# ADDENDUM No. 1

## ITB No. 4525

### CREST BUENA VISTA WASHINGTON WATER MAIN PROJECT

DRAWING NO. 2016029-19

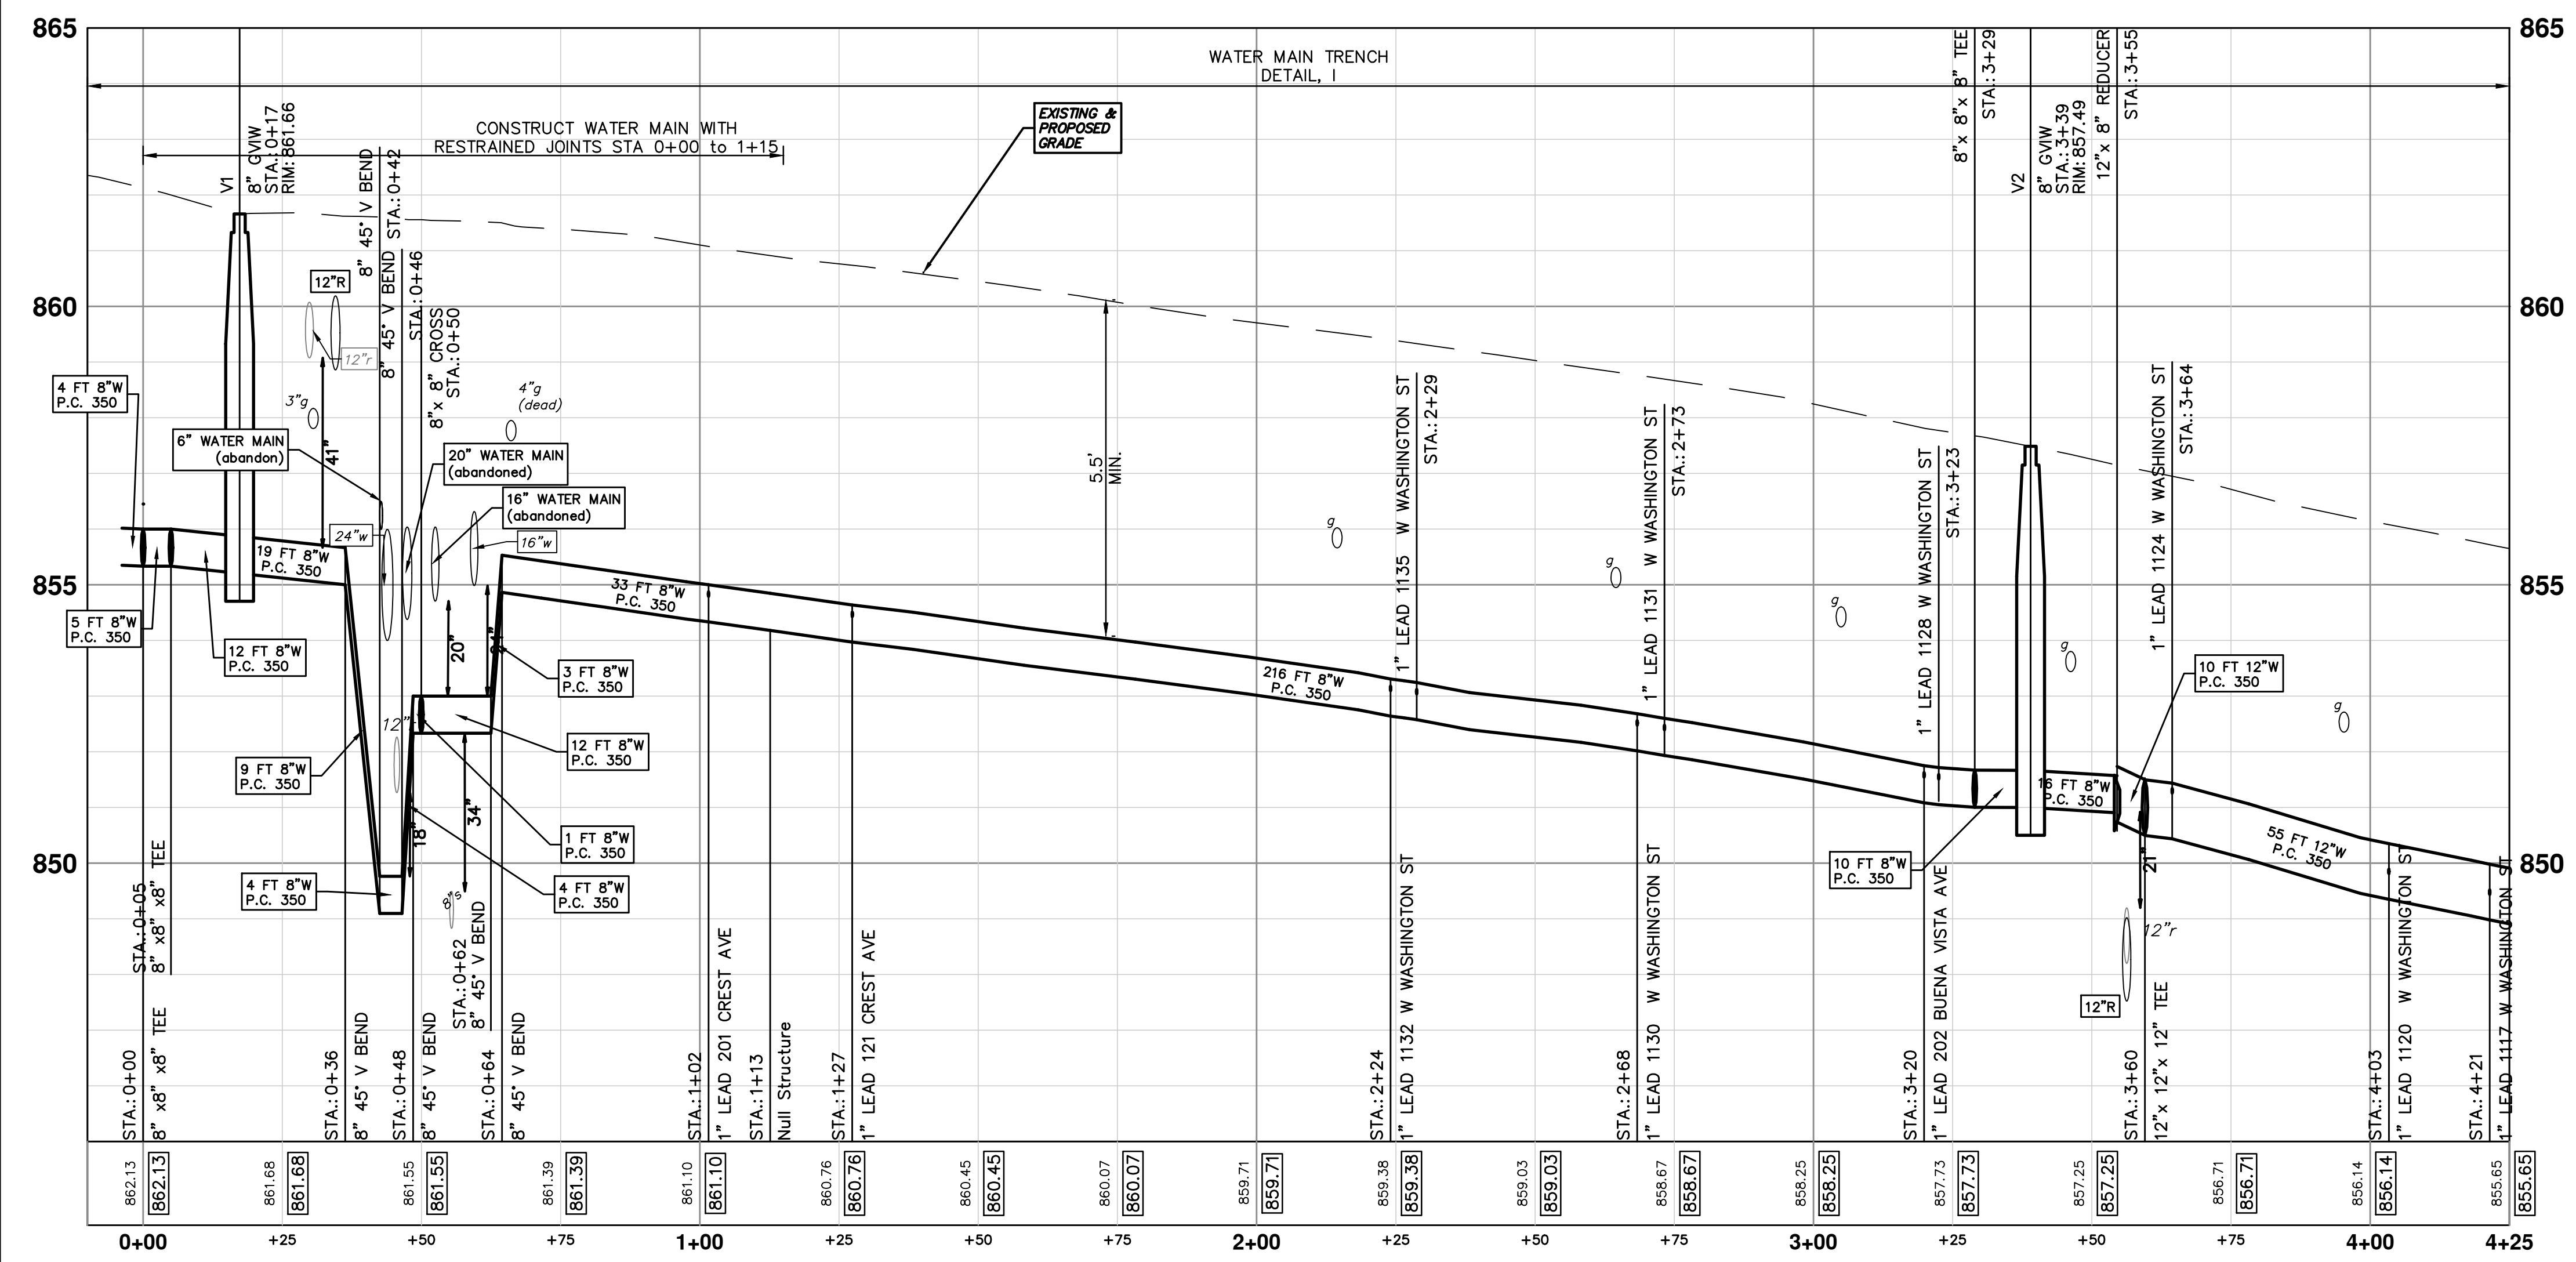
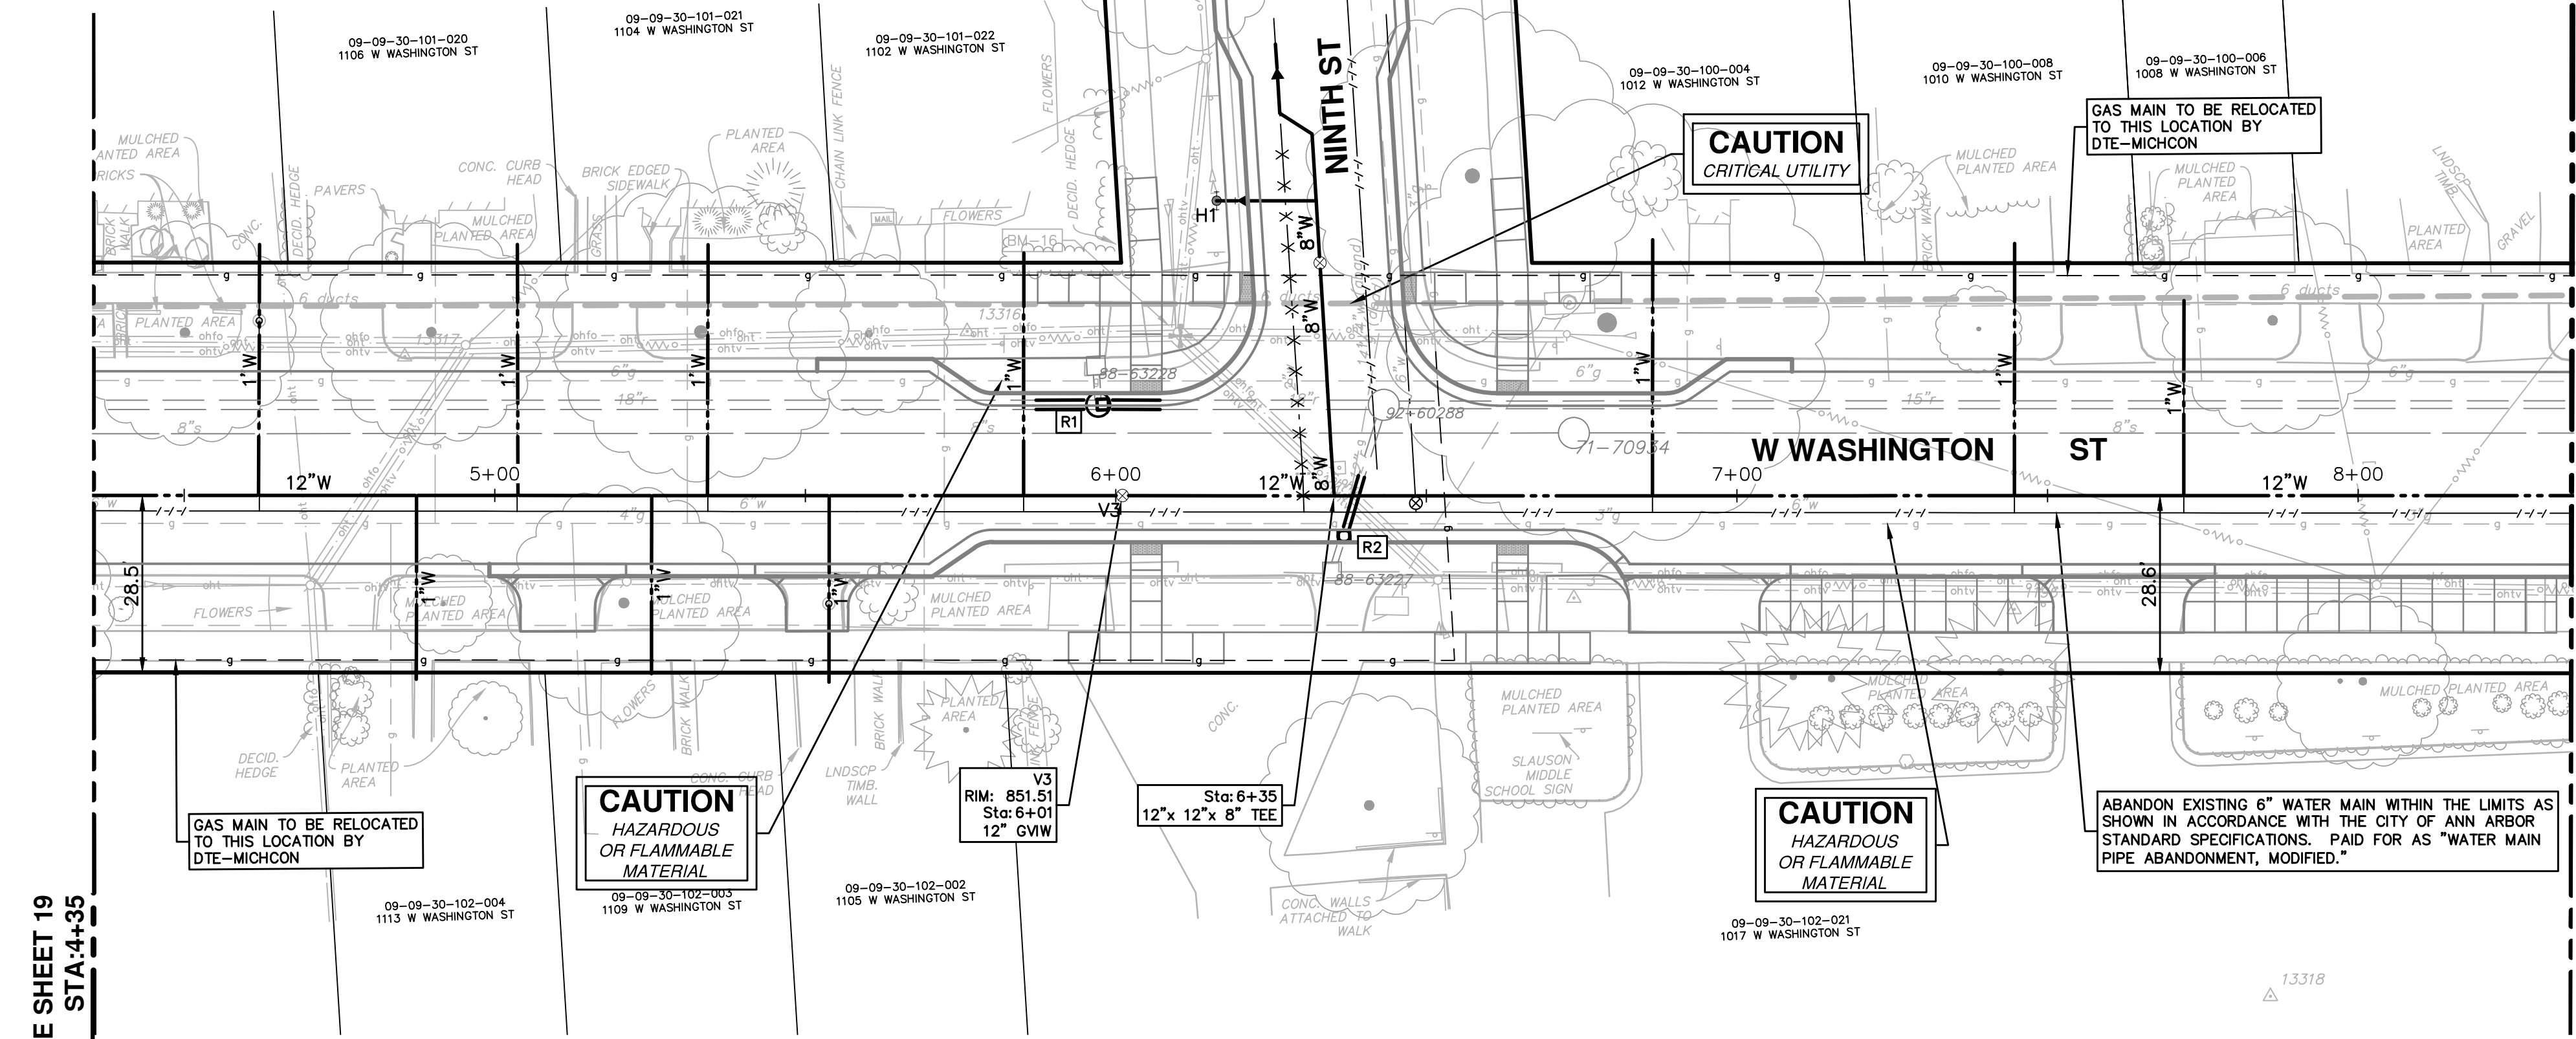
On plan sheet 19, new storm features were added and Water Main Construction Notes.
